STAFF REPORT
COMMUNITY DEVELOPMENT DEPARTMENT

SUBJECT: H-2022-0066
 Artisan Victory Market – AZ, CUP, PP, PS

LOCATION: 2820, 2910, 2960, 2990 and 3020 S. Eagle Rd., in the SW 1/4 of Section 21, T.3N., R.1E. (Parcel #S1121336051; S1121336101; S1121336176; S1121336200; S1121336230; S1121336251; and S1121336276)

B. Preliminary Plat (dated: 03/15/2023)

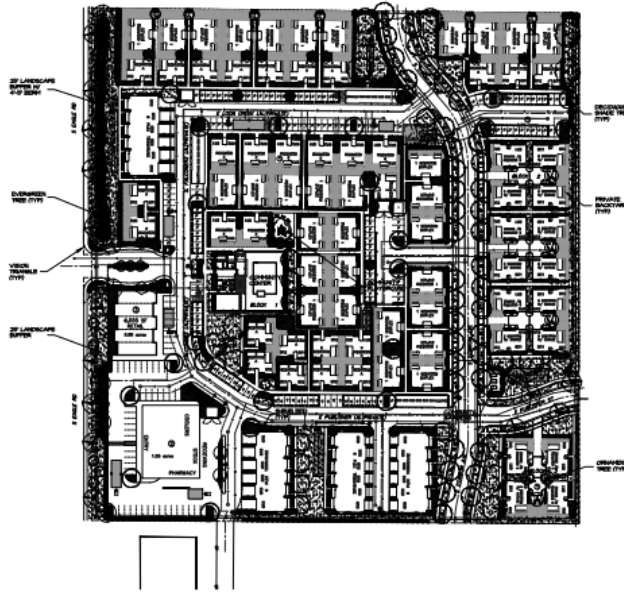
The units located on the east side of Titanium take access from shared driveways. Although not classified as common driveways, the applicant should provide at a minimum 20-foot driveways to ensure vehicles can access the designed garage spaces associated with those units. With the CZC application the applicant should demonstrate compliance with this requirement.

As is, the private street connection to Eagle Rd. does not currently meet all of the required standards and cannot be approved; a request for alternative compliance may be submitted for consideration by the Director. Staff recommends the applicant submit the alternative compliance application 15 days prior to the City Council hearing. If the portion of the Eagle road access is not part of the private street, the applicant should depict the ingress/egress easement on the face of the plat to allow access to the platted private streets. Further, the plat should be revised to place the private street in a common lot rather than an easement.

C. Landscape Plan & Fencing Plan (dated: 03/20/2023)

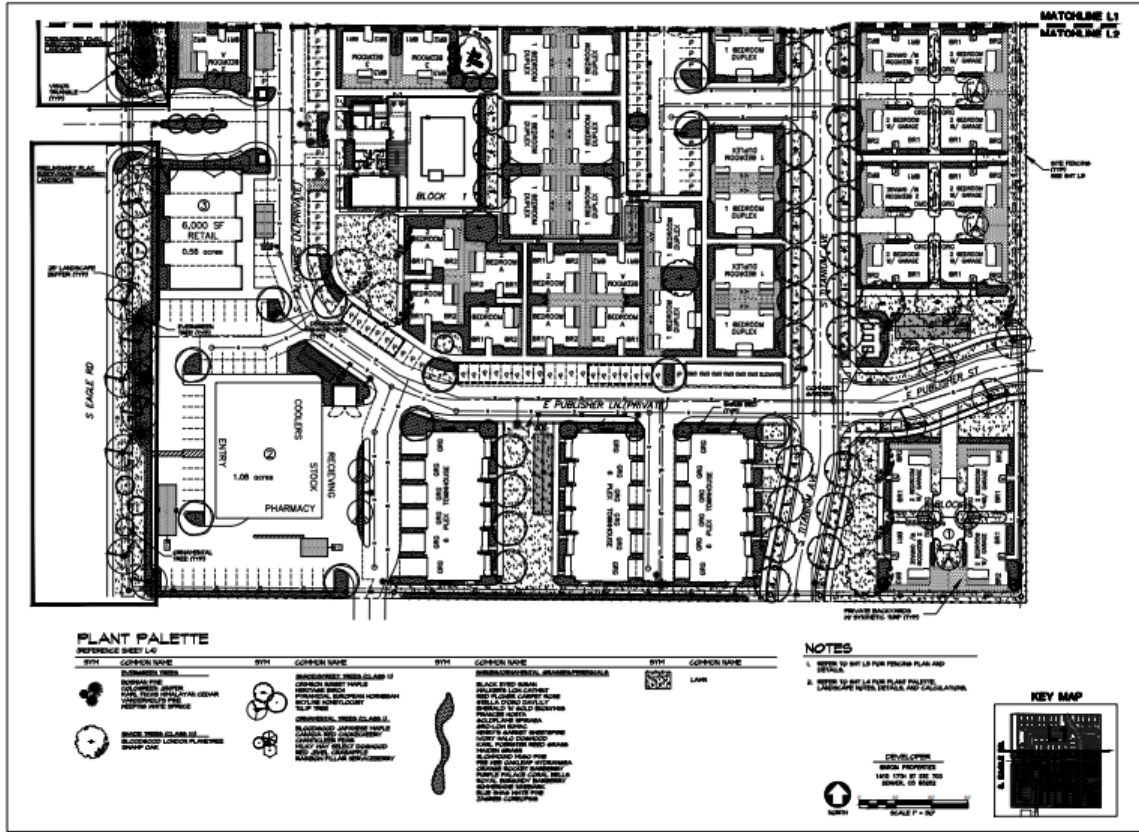
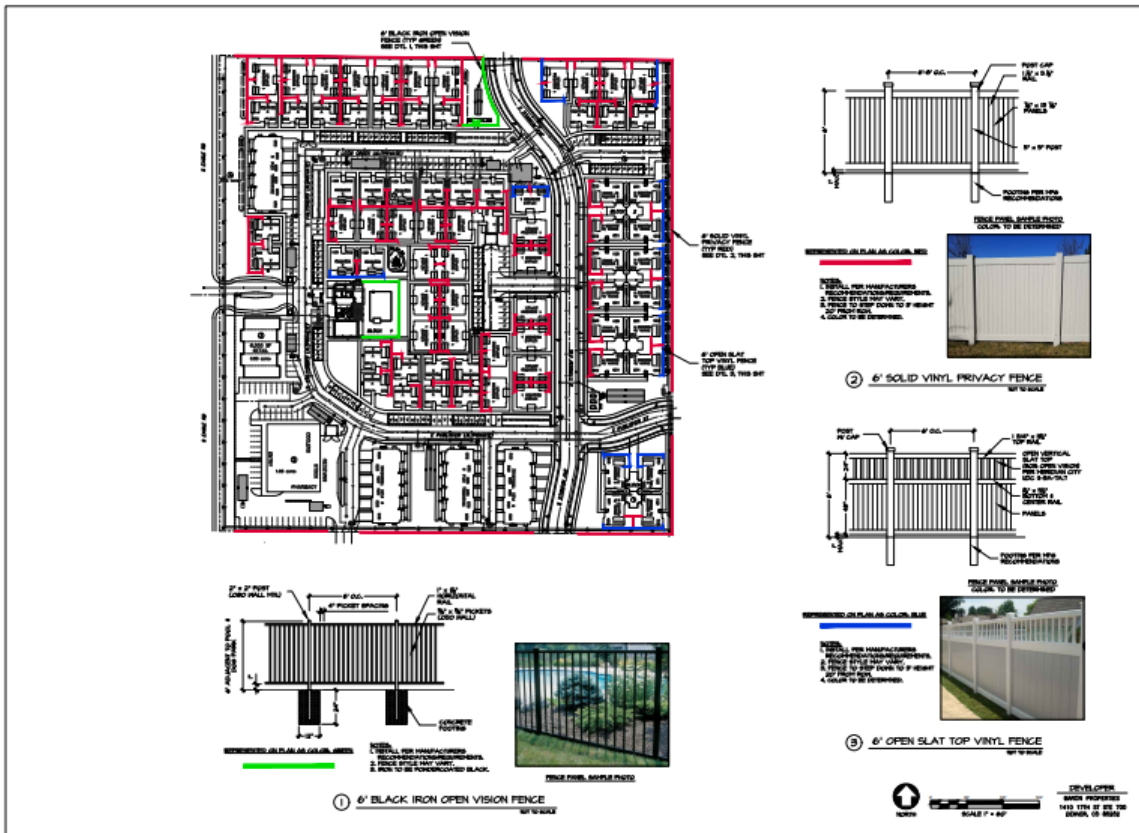
There are existing trees on the site to be removed or that require mitigation. **The landscape plan submitted with the final plat should include the detail mitigation plan in accord with UDC 11-3B-10.**

All fencing is required to comply with the standards listed in UDC 11-3A-7. The applicant has provided a master fence plan that depicts the fencing styles and locations for the development. A combination of 6-foot tall solid, 4-foot with 2 foot open-vision and 6-foot tall wrought iron fencing is proposed. **With final plat submittal, any fencing proposed along Publisher and Titanium should be installed 10 feet from the property line.**

3. The landscape plan submitted with the final plat shall be revised as follows:
 - a. Landscaping is required within the street buffer as set forth in UDC [11-3B-7C](#). (*See updated standards.*)

6. The landscape plan submitted with the final plat shall include the detail mitigation plan in accord with UDC 11-3B-10.
7. All structures on the property shall be removed for the site with development of the subdivision.
